1st Further Information

**Proposed Temporary Open Storage of Construction Materials with Ancillary Facilities
for a Period of 3 Years in "Comprehensive Development Area (1)" Zone,
Various Lots in D.D. 107 and Adjoining Government Land, Fung Kat Heung, Kam Tin, Yuen Long**

(S.16 Planning Application No. A/YL-KTN/1041)

Responses-to-Comments

SCALE 1: 1500 @ A4	
DRAWN BY MN	DATE 17.7.2024
CHECKED BY	DATE
APPROVED BY	DATE
DWG. TITLE SWEPT PATH ANALYSIS (1/2)	
DWG NO. PLAN 1	VER. 001

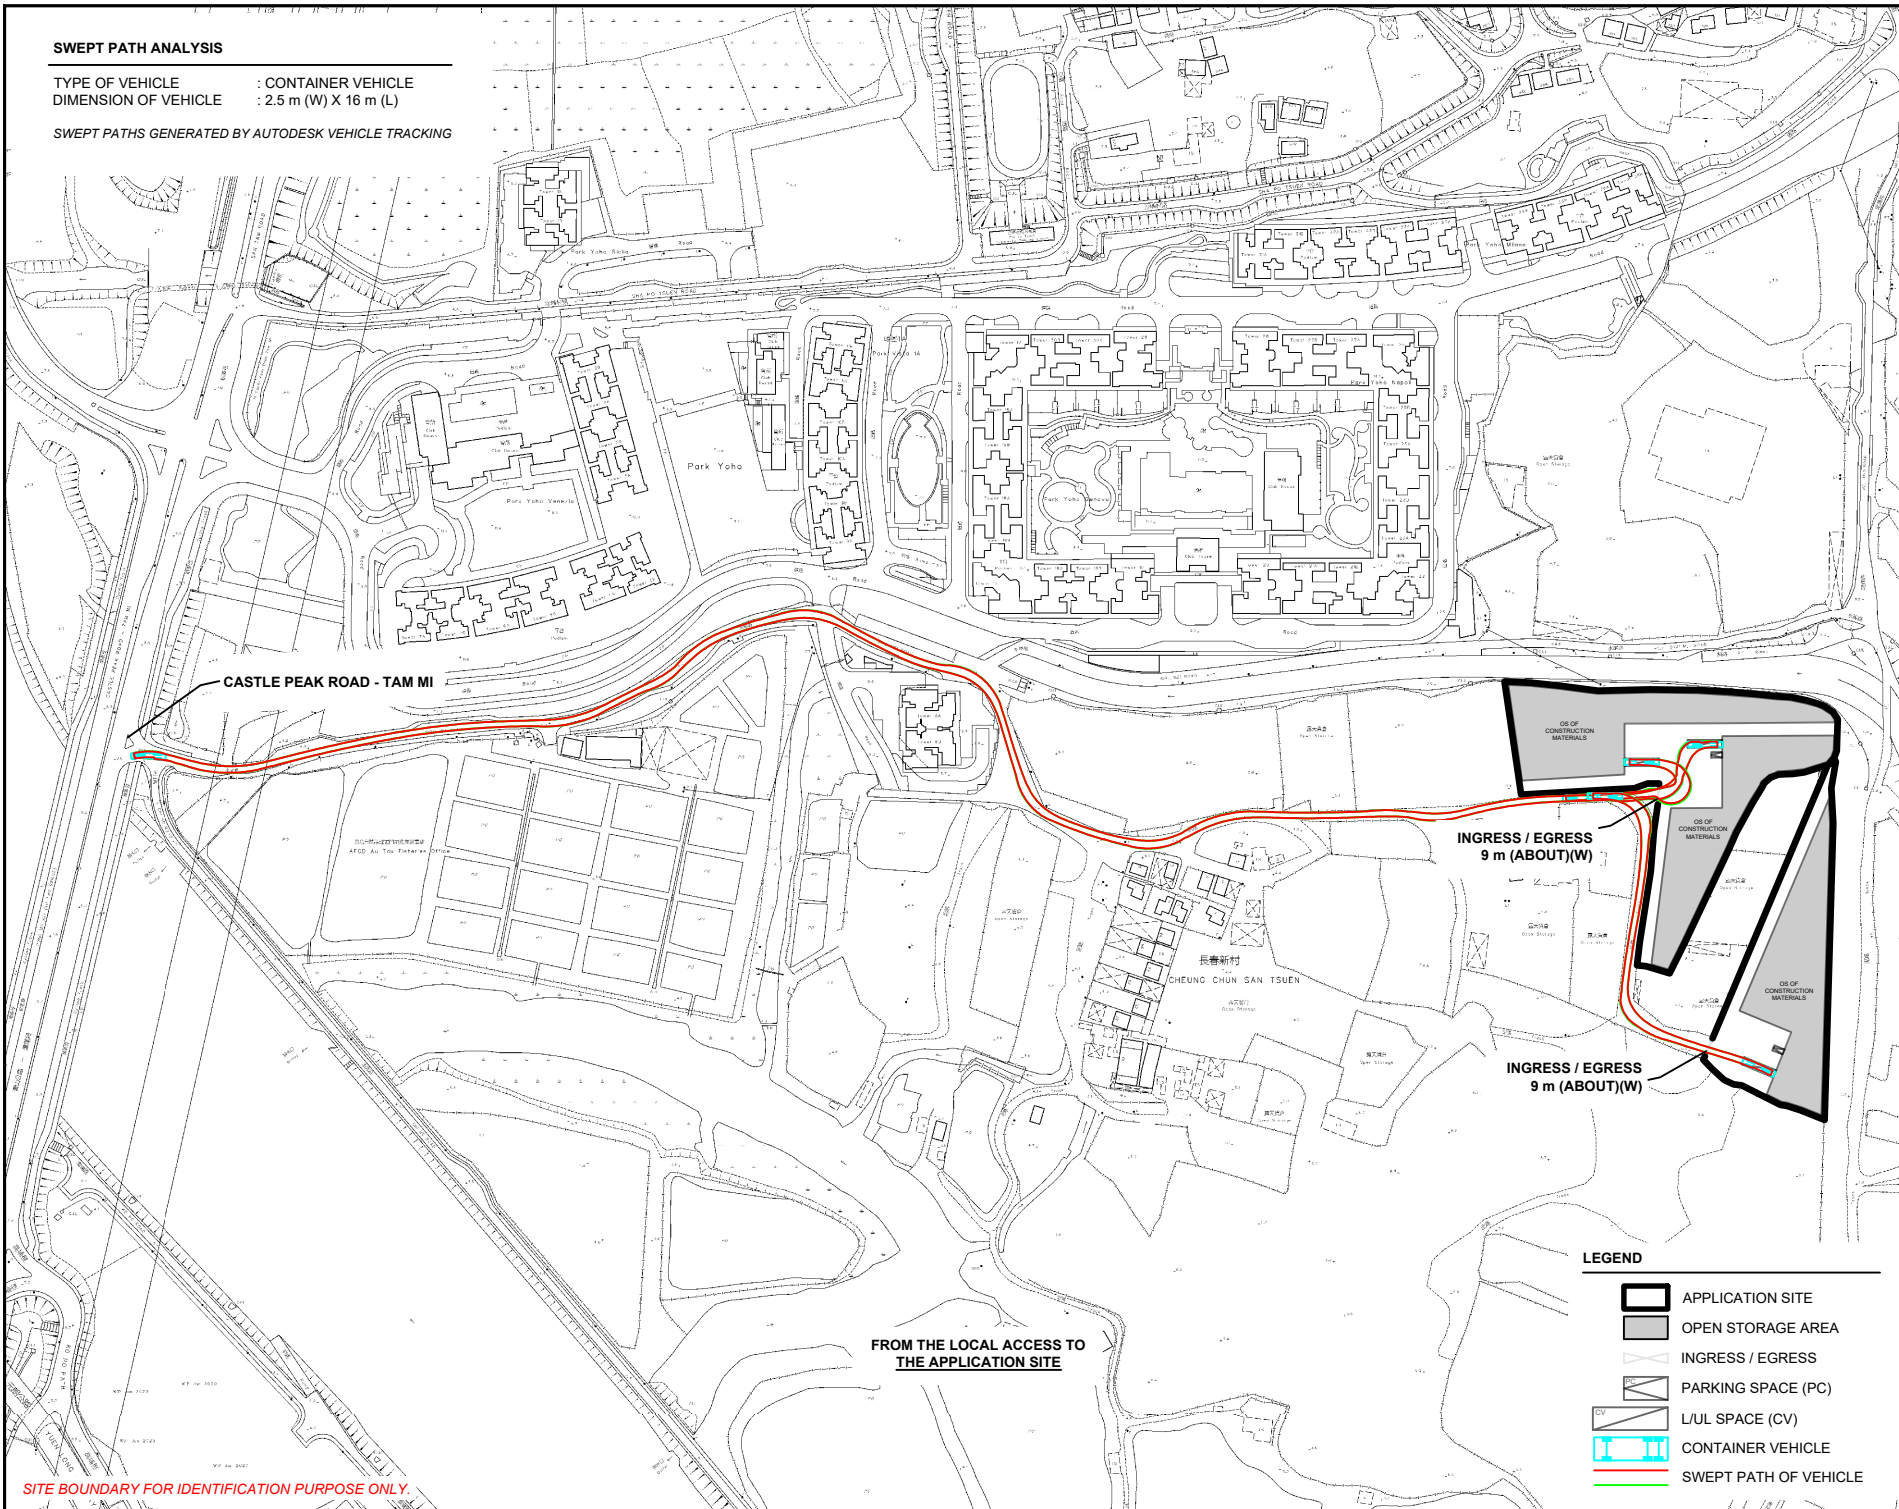
(a)	The applicant should demonstrate the smooth manoeuvring of vehicles, e.g. container vehicle, to / from Castle Peak Road - Tam Mi, along the local access and within the site.	The swept path demonstrations are shown in Plans 1 and 2 .

PLAN 3

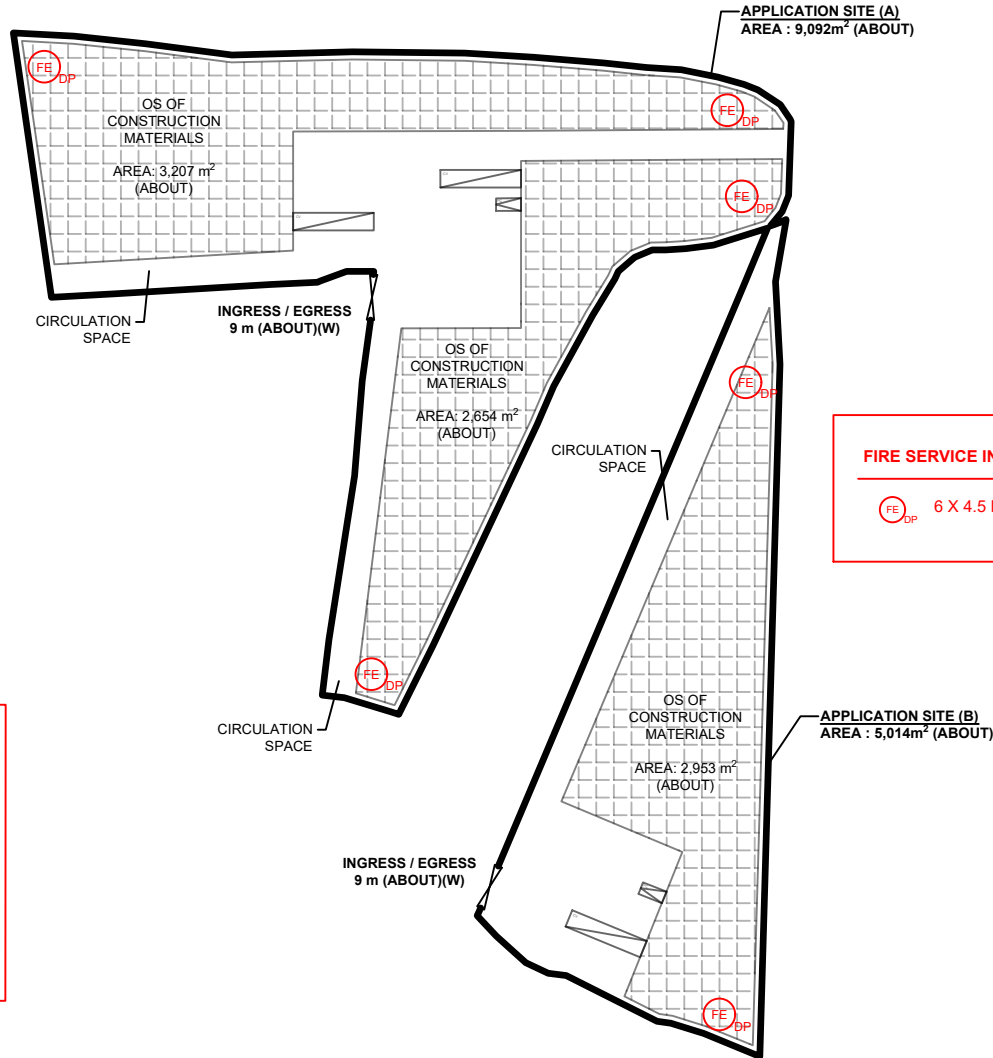
(b)	The applicant should provide the routing between Castle Peak Road - Tam Mi and the site.	The routing between Castle Peak Road – Tam Mi and the application site (the Site) is provided (Plan 3).

Figure 4.1 – Proposed Layout of the Drainage Channel for the Project Site

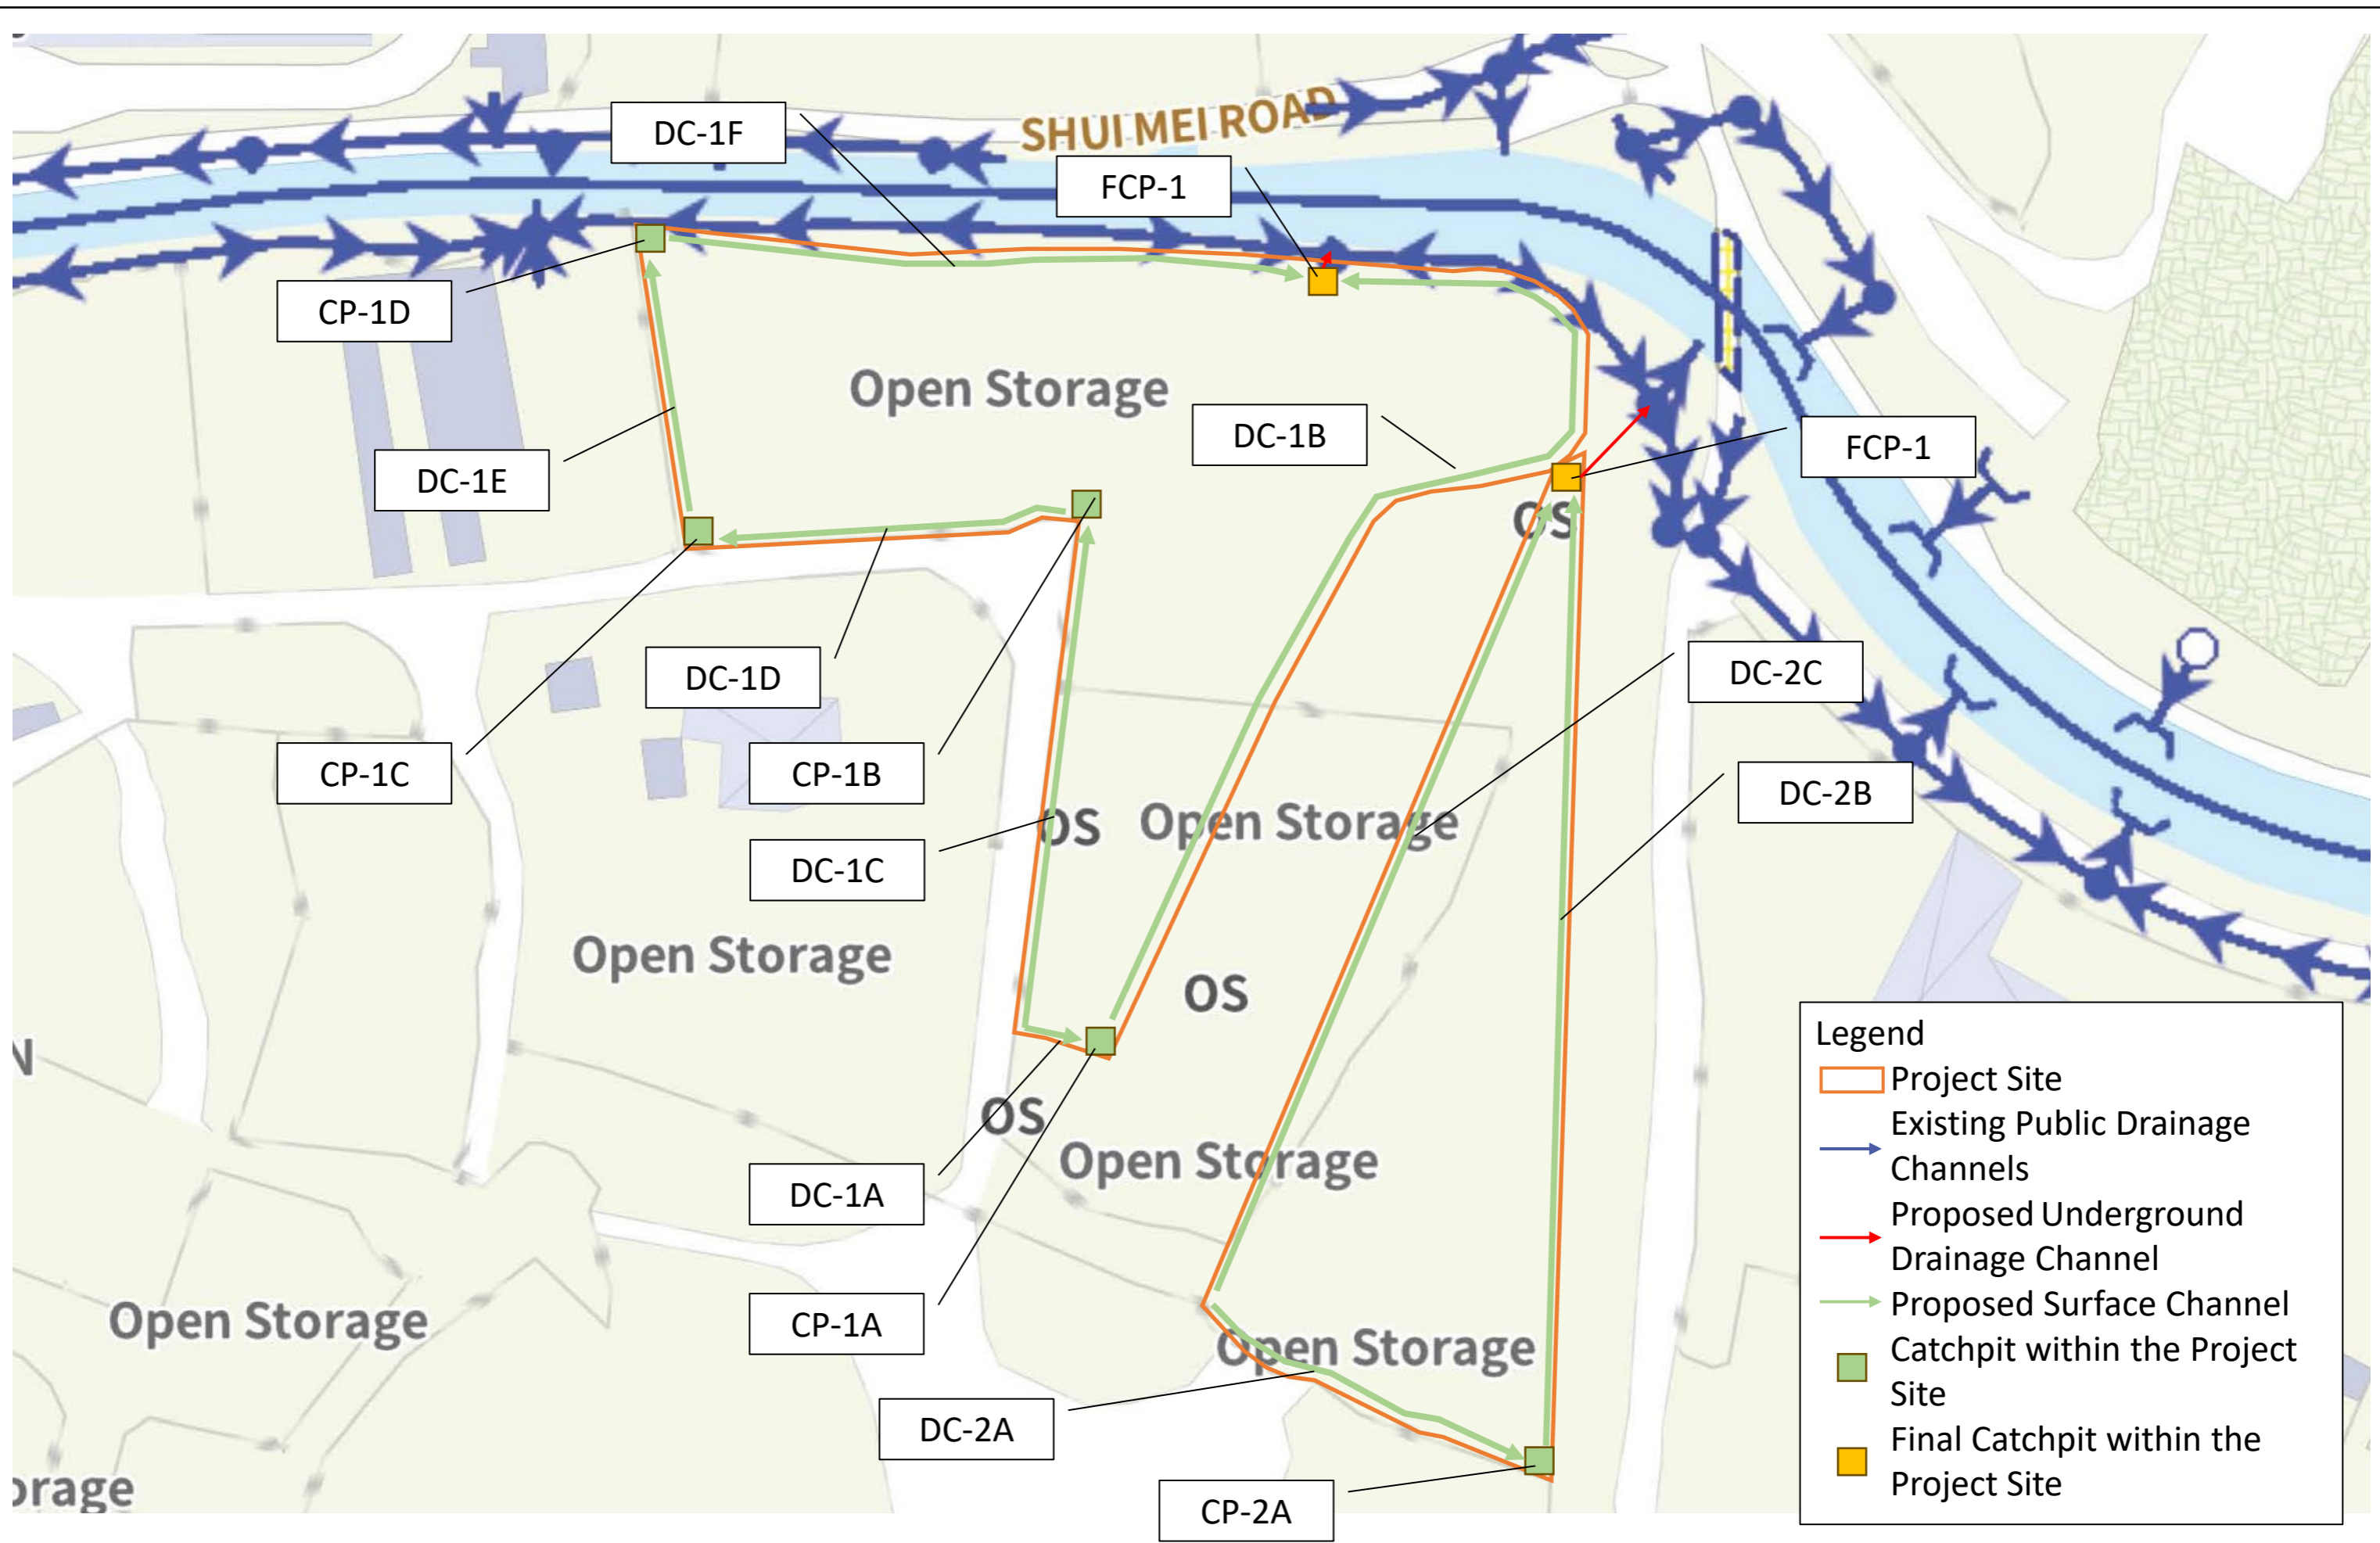
(a)	<p>Considering the large area of proposed development, a Drainage Impact Assessment is required for the application.</p>	<p>A Drainage Impact Assessment (DIA) report is submitted by the applicant to review the drainage arrangements for the proposed development, and the DIA concluded that adverse drainage impact from the proposed development should <u>not</u> be anticipated (Annex II).</p>

4.2.4 Within the Project Site, a series of U-channel has been allocated at the Project Site and the layout is given in **Figure 4.1**. The percentage of maximum of full capacity under the peak flow for the proposed drainage channels have been summarised in **Table 4.1**. Detailed calculation is given in **Appendix 4.3**.
